**MEMORANDUM REPORT
NUMBER 72**

**ANALYSIS OF TRAFFIC ENGINEERING ACTIONS
PROPOSED BY CITY OF CEDARBURG STAFF FOR
S. WASHINGTON AVENUE (STH 57/STH 143)**

On March 5, 1990, the City of Cedarburg requested the Commission staff to review and comment upon several traffic management actions being considered for implementation on S. Washington Avenue--STH 57-STH 143--in the central business district of the City of Cedarburg. The actions being considered were the installation of traffic signals at the intersection of W. Western Road and Washington Avenue--STH 57; the addition of flashing amber crosswalk beacons at certain locations along S. Washington Avenue--STH 57-STH 143--between E. Hamilton Road and N. Sheboygan Street; and additional parking restrictions at certain locations on S. Washington Avenue--STH 57-STH 143. This staff memorandum presents the findings and recommendations of the Commission staff review.

LOCATION OF PEDESTRIAN INVOLVED
MOTOR-VEHICLE ACCIDENTS: 1988-1990

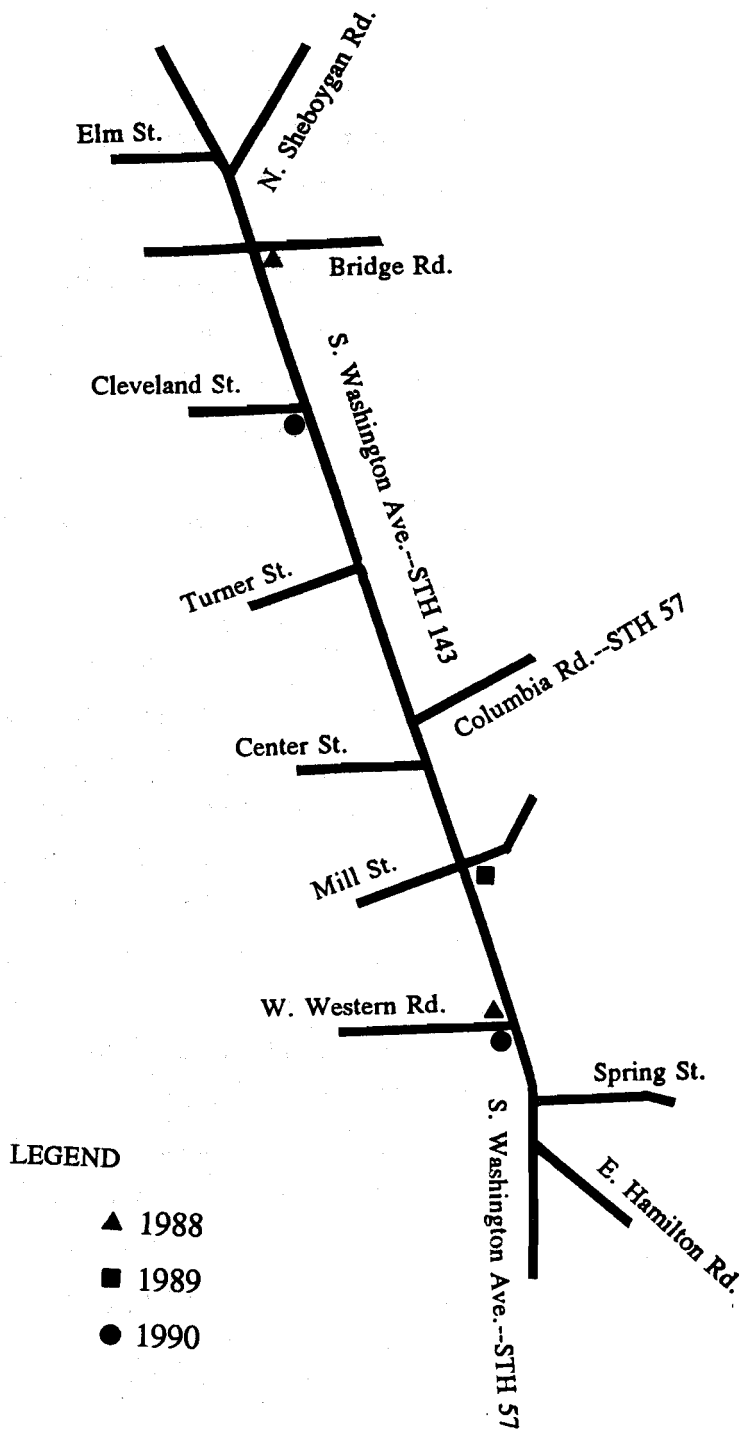
Shown on Figure 3 are the locations where the pedestrian-vehicular accidents occurred on S. Washington Avenue--STH 57-STH 143--within the three year period considered. As already noted, two of the pedestrian-vehicular accidents occurred at the intersection of S. Washington Avenue--STH 57--and W. Western Road. The remainder of these accidents occurred at various locations. Thus, it may be concluded that no particular location is more hazardous than any other, with the exception of the S. Washington Avenue--STH 57--and W. Western Road intersection which, with two pedestrian-vehicular accidents on the W. Western Road approach may be modestly more hazardous than other locations. The installation of traffic signals, including pedestrian signals, may be expected to improve pedestrian safety at this intersection.

LADDER PAVEMENT MARKING OF
CROSSWALK LOCATED AT COMMUNITY CENTER

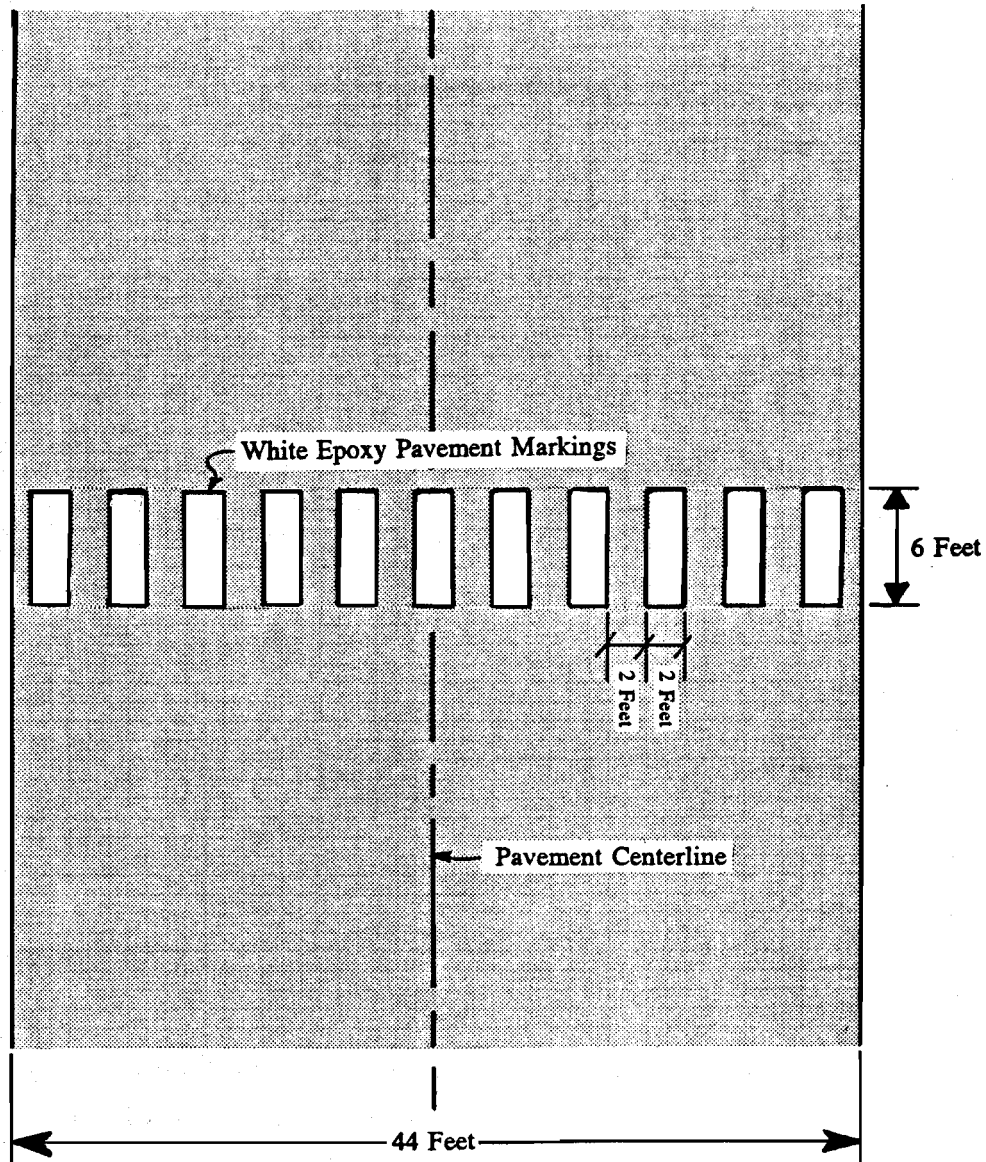
The second alternative action considered to alleviate the prevalent accident type on the study segment was to improve the visibility of the crosswalks between E. Hamilton Road and N. Sheboygan Road using epoxy pavement markings to provide a more visible reminder to motorists of the potential for the presence of pedestrians. Because the crosswalk at the Community Center is a mid-block crosswalk and may thus be unexpected by motorists, a ladder pattern, as shown in Figure 5, was considered to delineate the crosswalk at this location.

The advantage of epoxy pavement markings are increased visibility year-round of the crosswalks and a life expectancy of the markings measured in years compared to months for paint. The advantage of the ladder pattern for the mid-block crosswalk at the Community Center is increased visibility compared to the standard crosswalk delineation. The disadvantage of this action is the increased cost of the material compared to typical pavement marking paint.

It is recommended that this action be implemented, as existing pavement markings require replacement. The cost is estimated at \$3,280.

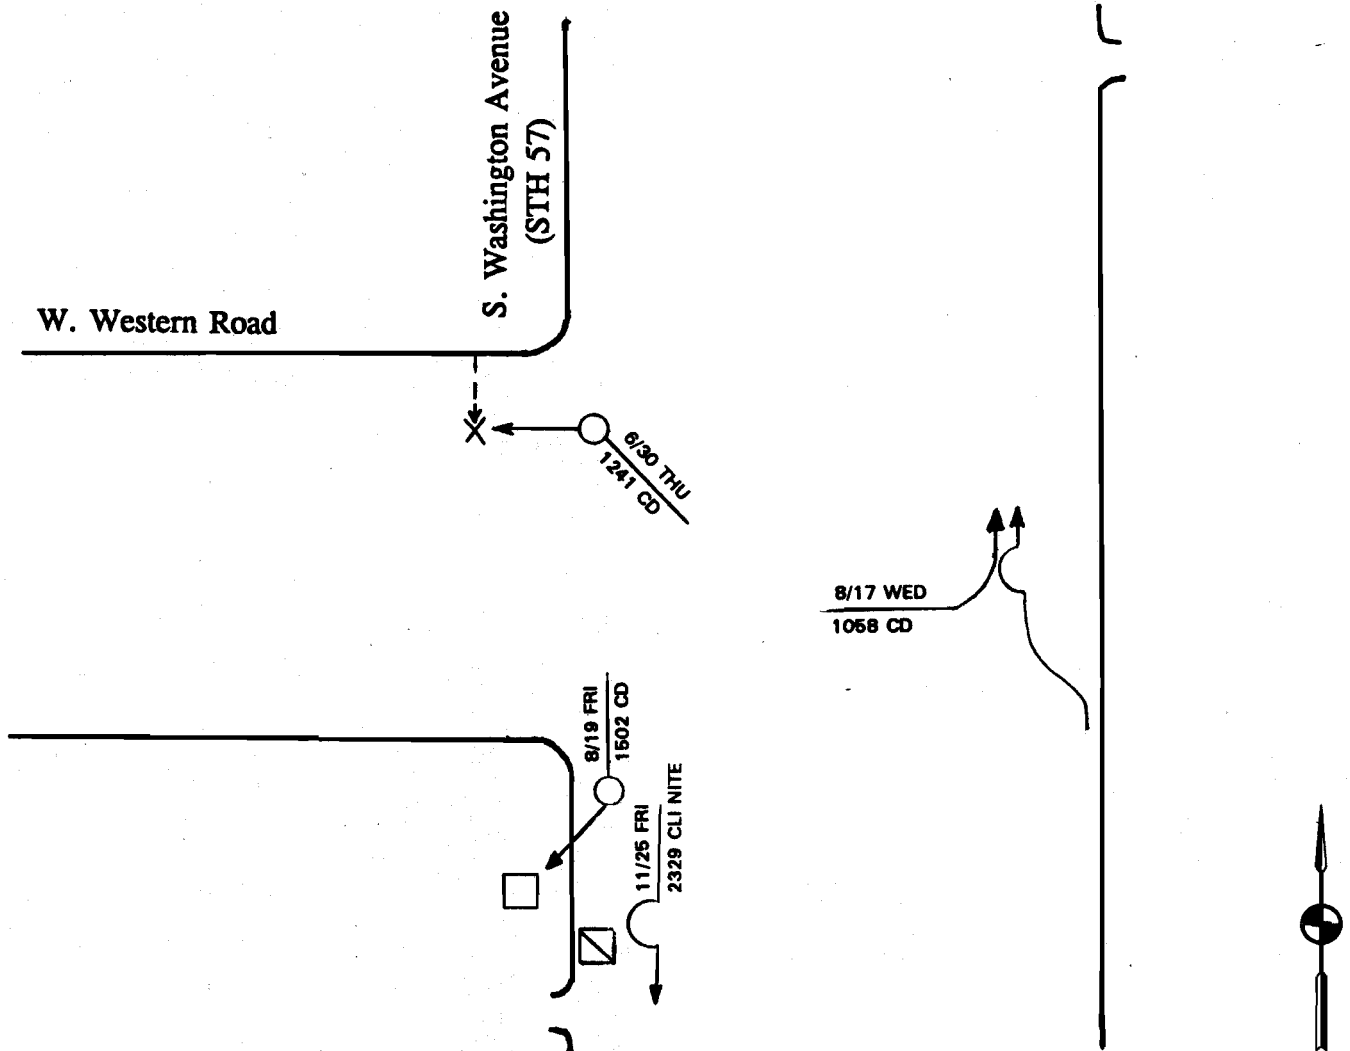
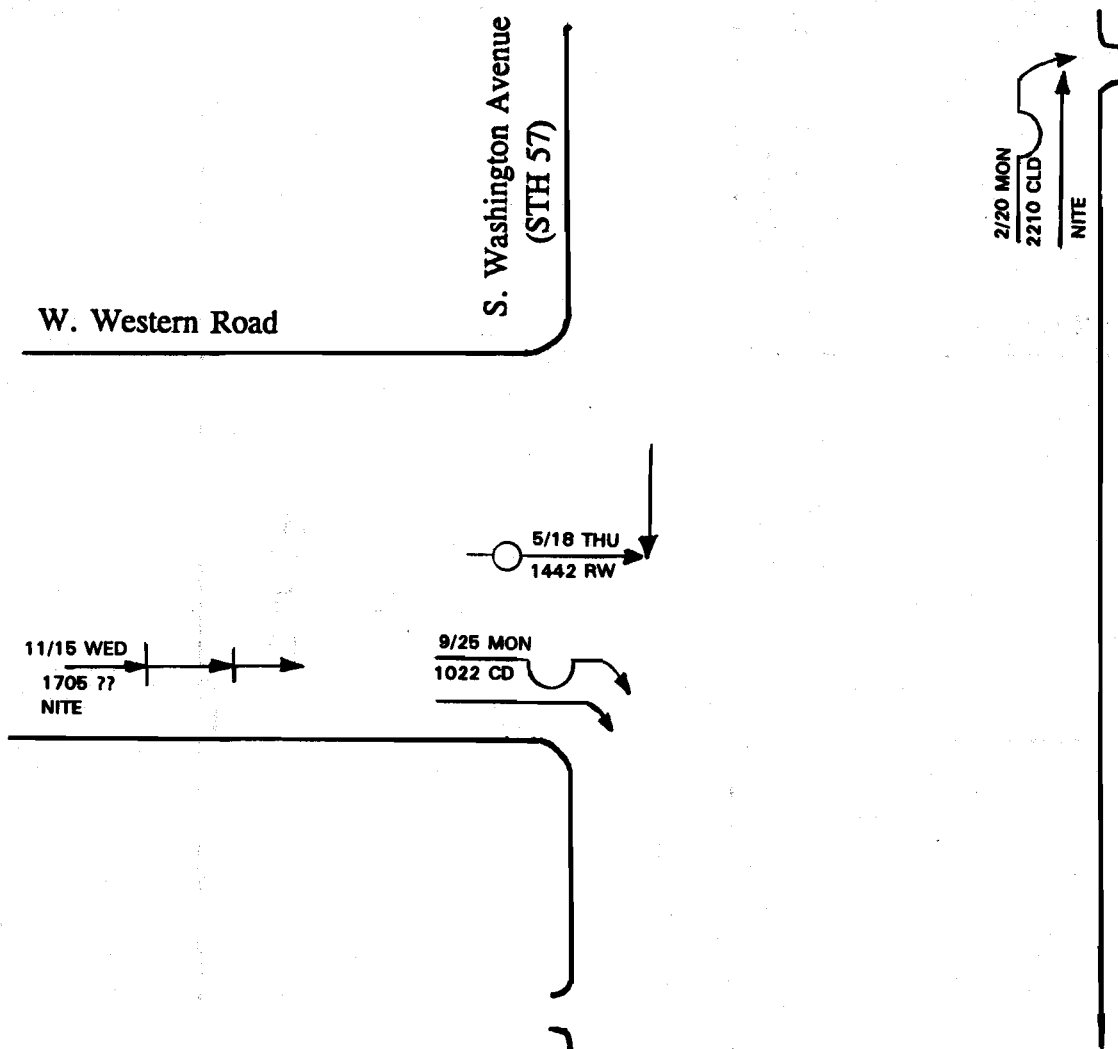
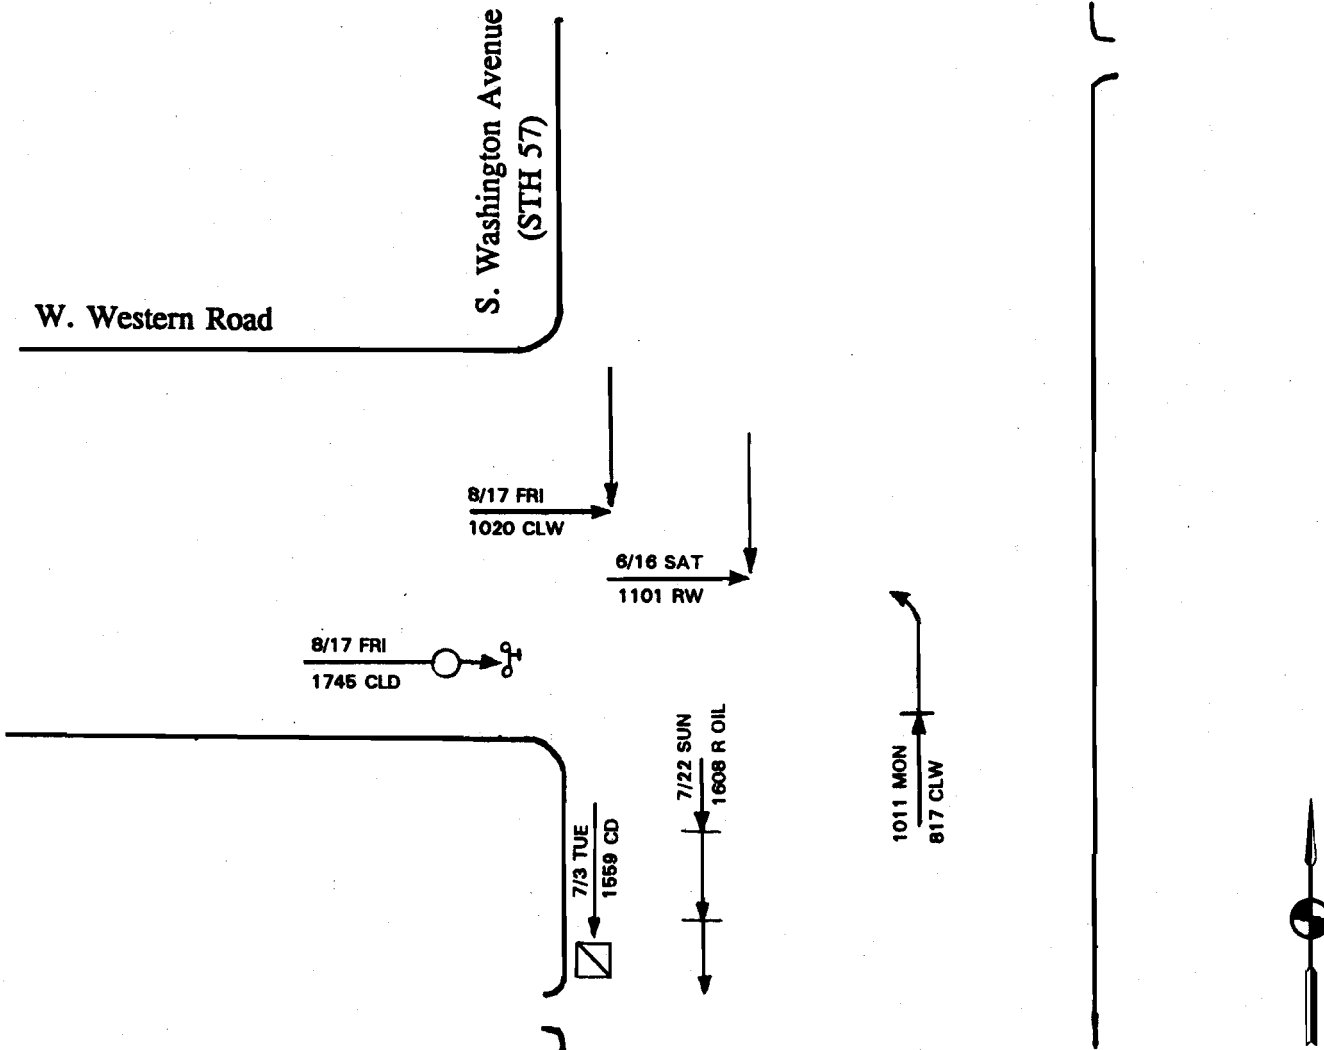
Two of the four traffic accidents in 1988 at the intersection can be considered to be correctable by the installation of a traffic signal; one of the four accidents in 1989 may be considered to be so correctable; and three of the six accidents in 1990 may be considered to be so correctable. Because five or more correctable traffic accidents did not occur during any 12 month period considered, the accident experience warrant is not satisfied. However, the warrant was nearly satisfied between May 1989 and August 1990, when four traffic accidents occurred which can be considered susceptible to correction by signalization. Further, three of these accidents occurred in 1990, a substantial increase compared to 1989. The collision diagrams for each year are shown in Appendix A.
